ADDENDUM A Staff Report: Z-30-21-2

Proposed Use PCD removal to allow multifamily residential

Location Southeast corner of the 29th Avenue alignment

CWS CAPITAL PARTNERS, LLC **BRONCO BUTTE MULTIFAMILY**

dwg no: SD1.00A

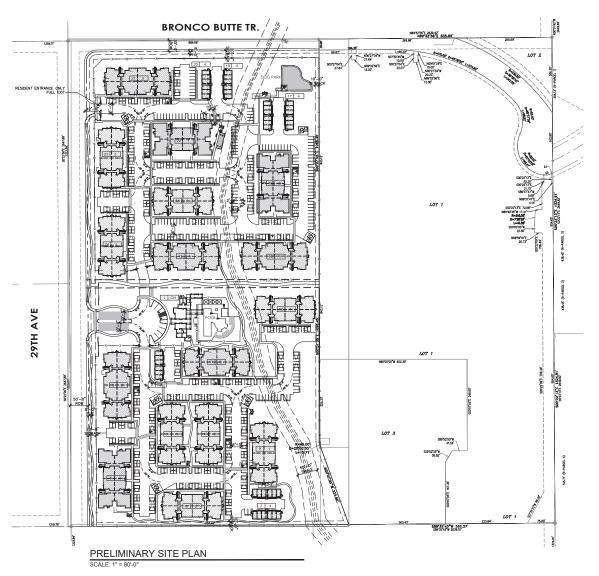
The purpose of this addendum is to revise a typographical error in the open space percentage on the site plan submitted with the case and subsequently included in the staff report. The original site plan included an incorrect open space calculation of 46 percent of the site. The applicant has since provided an updated site plan reflecting a corrected open space percentage of 16 percent. The remainder of the site plan information remains consistent with the originally submitted version.

PROVIDED: LOT COVERAGE: 185 015 / 827 012 = 22% OPEN SPACE: 151,764 / 910,592 = 16.66%
